Board of City Commissioners

3. **Consider the request from the Bismarck Airport for approval of Weisz and Sons Wetland Phase 5 Completion Contract Change Order No. 5 and Request to Wave Change Order Policy.**

Change Order No. 5
Date June 3, 2024

Airport Name	Bismarck Airport	Change Order No.	5
Location	Bismarck, ND	Section	3
AIP Project #	3-38-0003-0062-2020, 3-38-0003-0064-2020	KLJ Project #	1805-02200.3
Contractor	Weisz & Sons, Inc.	Owner's Project #	APG.AIP62.CONST, APG.AIP64.CONST

SHEET TITLE:
TOPO SUBGRADE ASBUILT

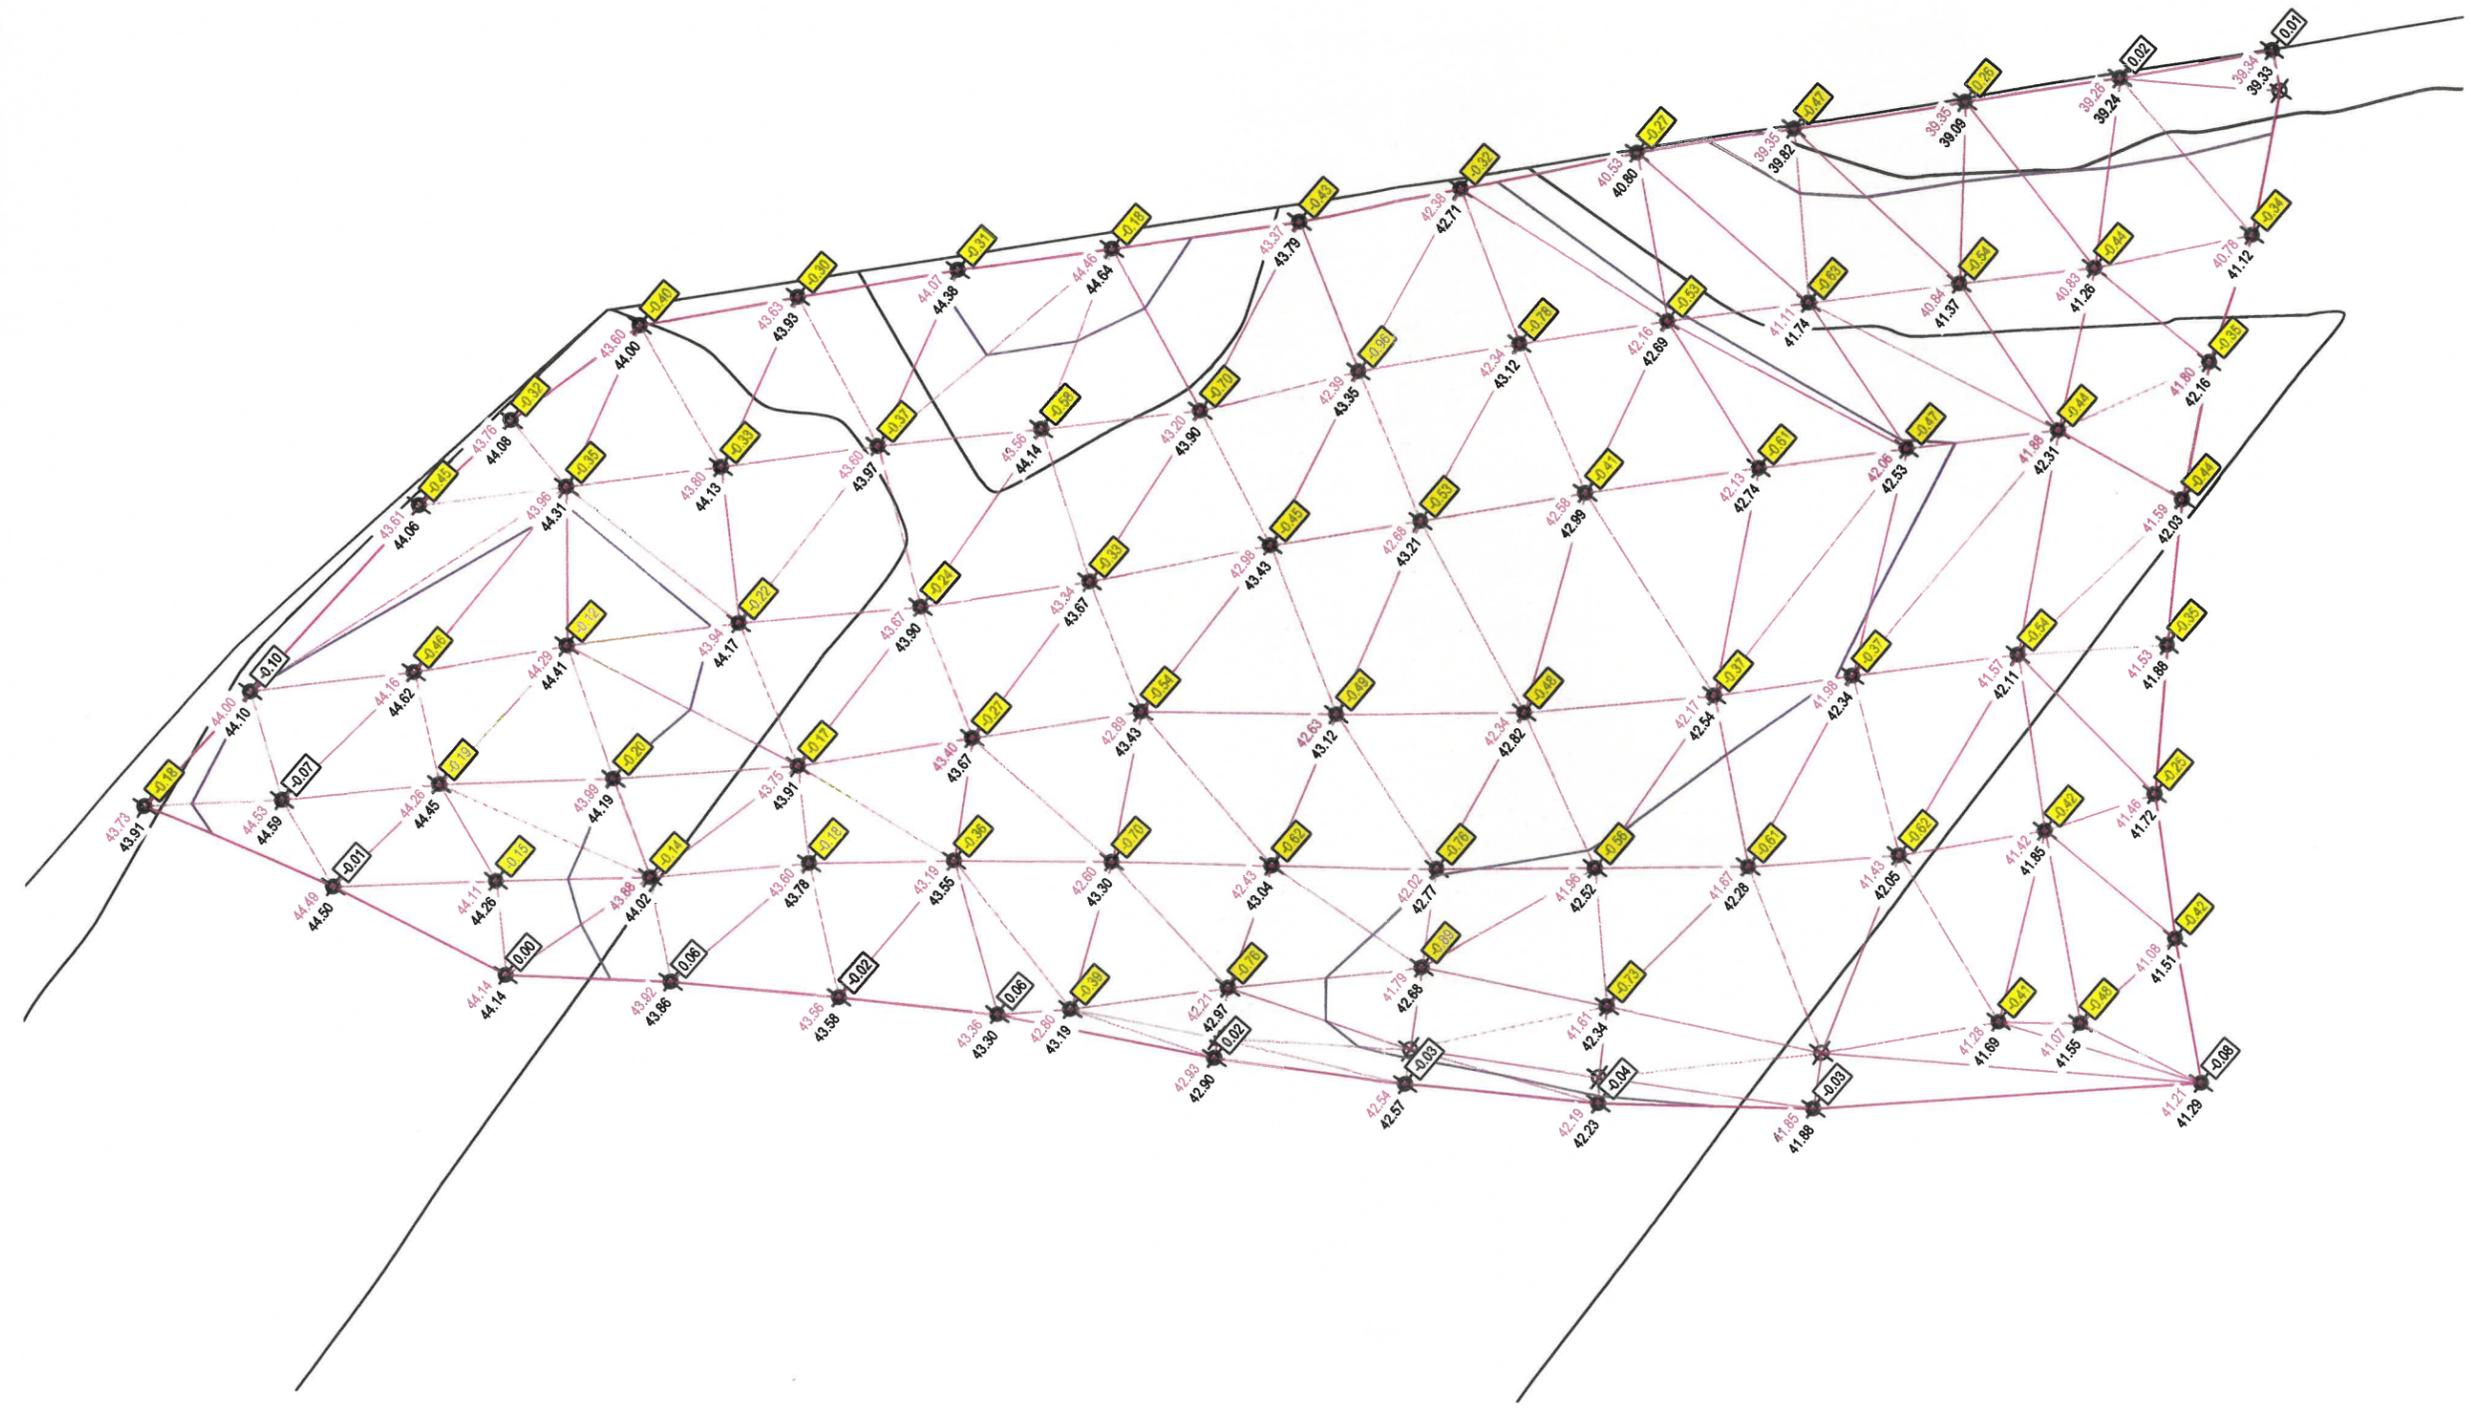
We have used all available subgrade dirt on the project. The following is our price per CY to borrow subsoil based on the plans and email supplied by KLJ on 12/12/2023. This price includes topsoil stripping, unclassified excavation, topsoil replacement, seeding and mulching.

1. SUBGRADE ASBUILT SURFACE PROVIDED BY MOUNTAIN PLAINS.
2. SUBGRADE ELEVATION IS 4-IN BELOW FINISHED GRADE SURFACE (DEPTH PROVIDED BY KLJ).
3. ERROR IS DETERMINED BY COMPARING ASBUILT SURFACE TO SUBGRADE SURFACE.
4. DEPTH EXCEEDING ±0.10 IS HIGHLIGHTED IN YELLOW AND CONSIDERED OUT OF TOLERANCE, UNLESS OTHERWISE APPROVED BY THE DESIGN ENGINEER
5. ELEVATION LABELS SHOWN IN PLAN VIEW ARE TO BE ADDED TO 1600 FEET.
6. ESTIMATED UNCOMPACTED FILL NEEDED = 1853.90 CU. YD.

Estimated Excavation Required
 1854 CY * 1.4 (shrinkage factor) = 2,596 CY

SHEET **15R.2**

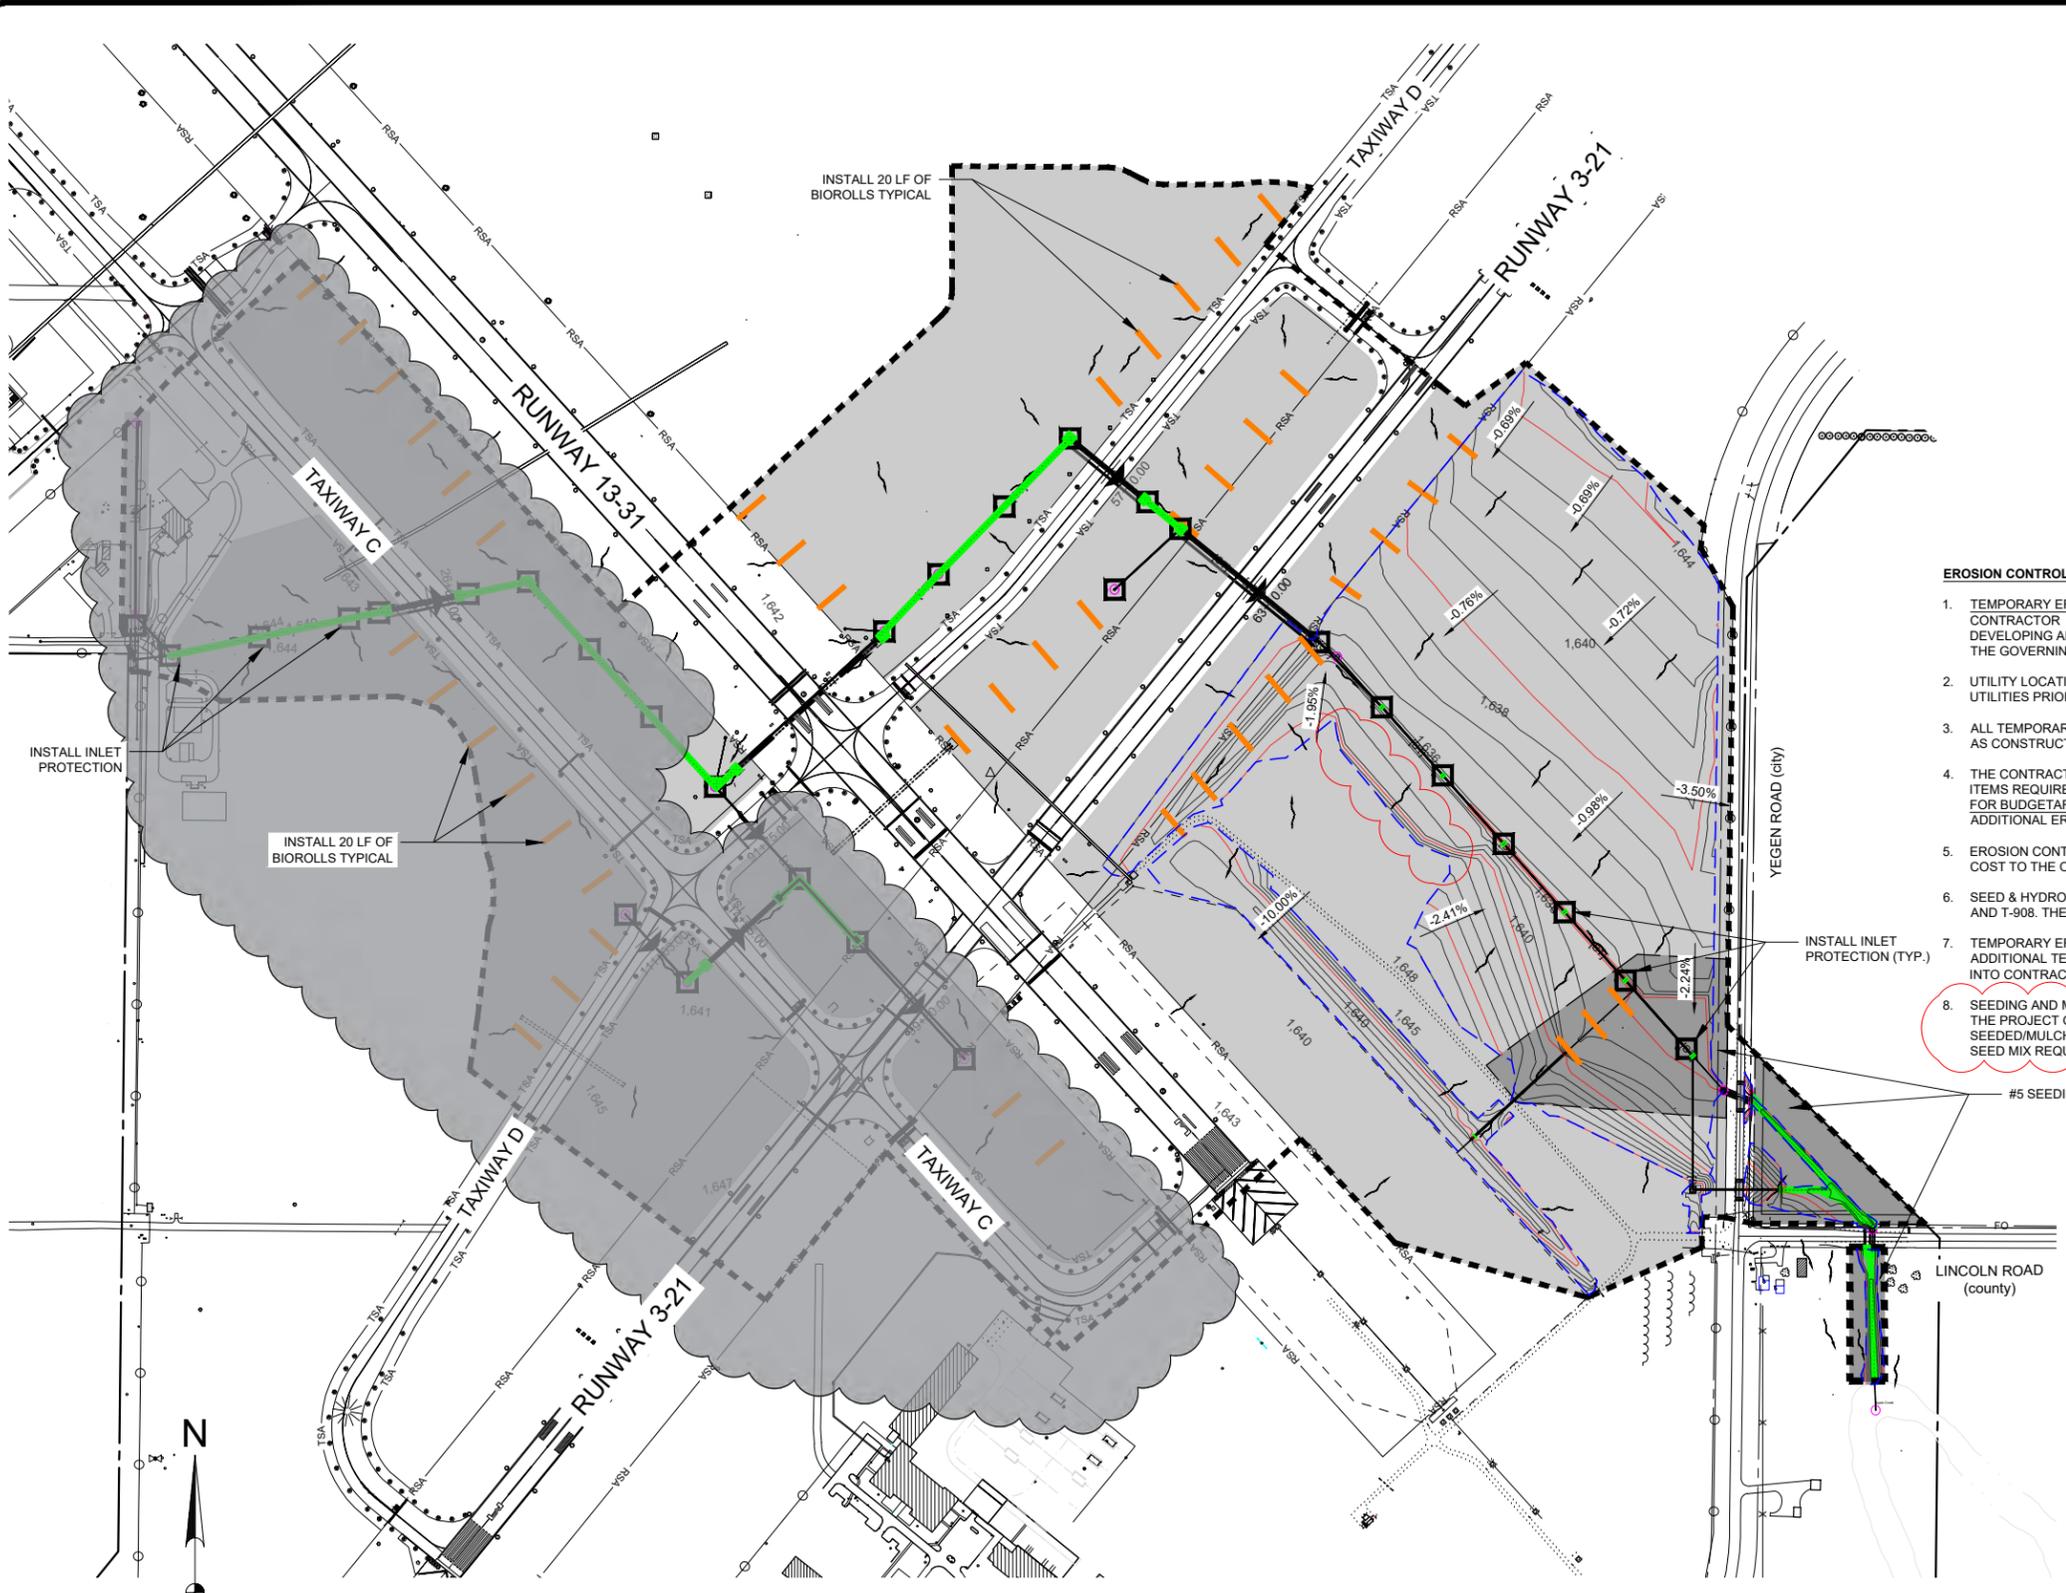
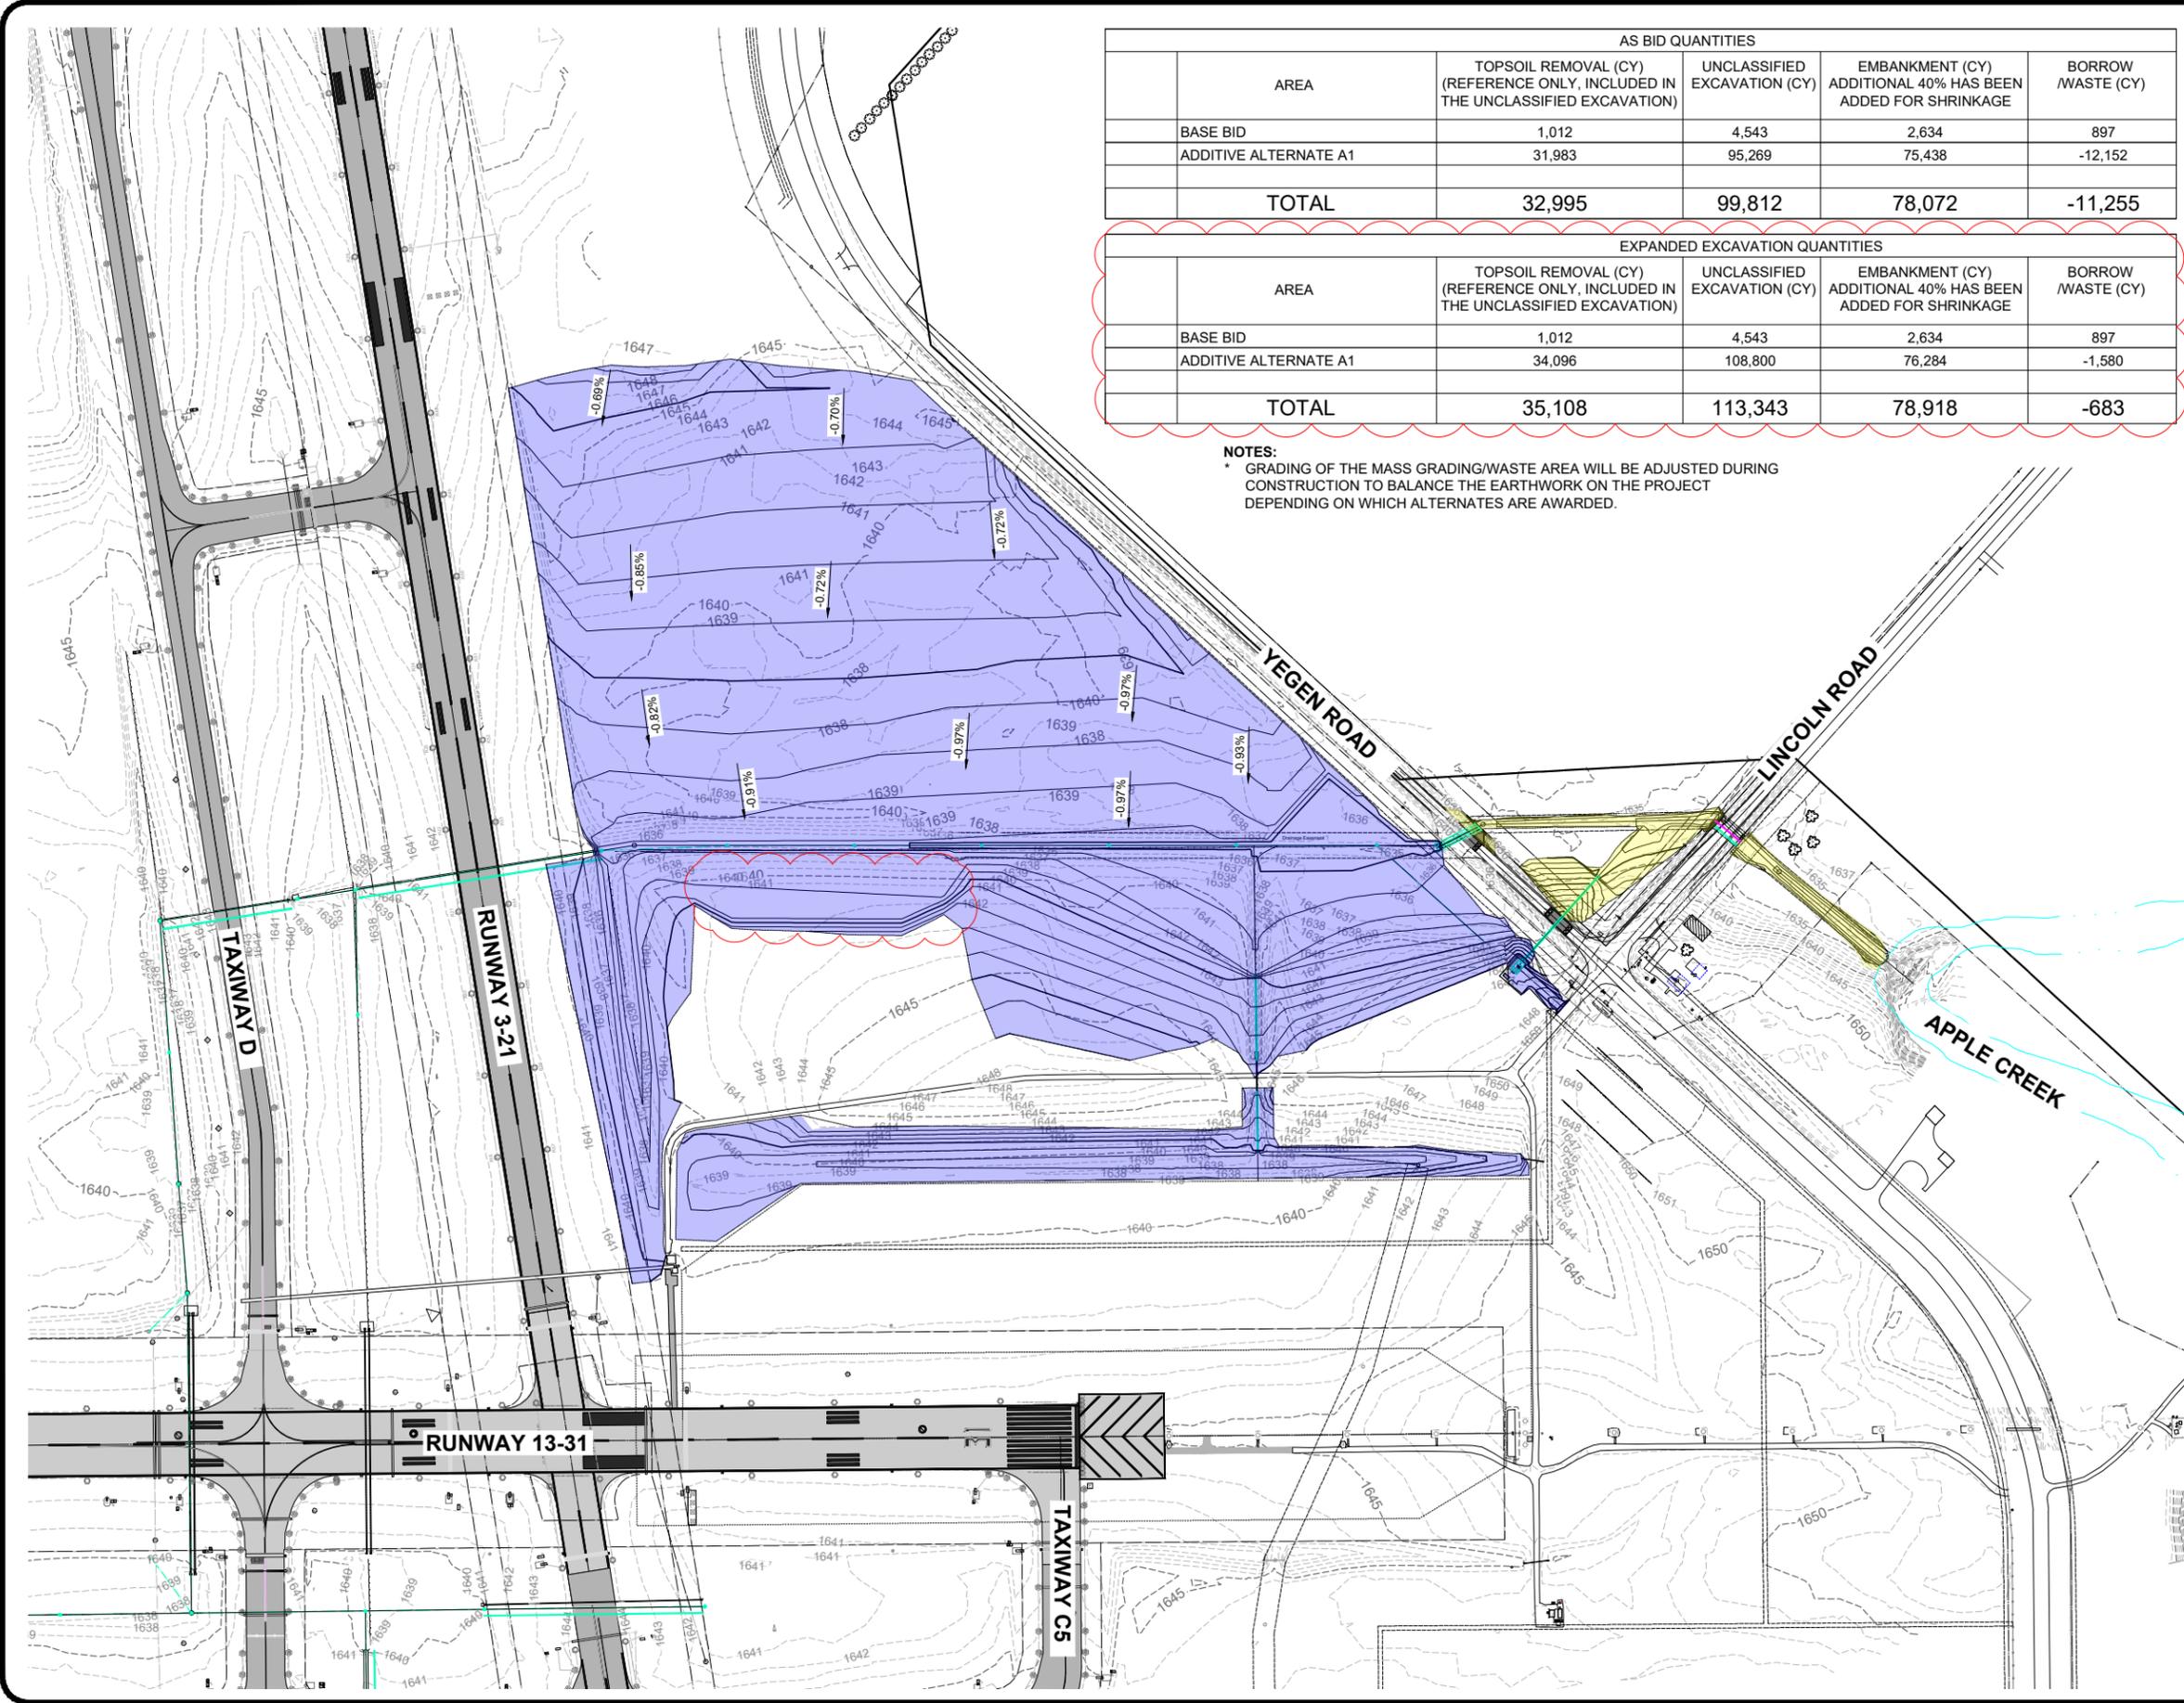
Replace plan sheets 15R, G-1R, G-3R with the attached revised plan sheets 15R.2, G-1R.2, G-3R.2.
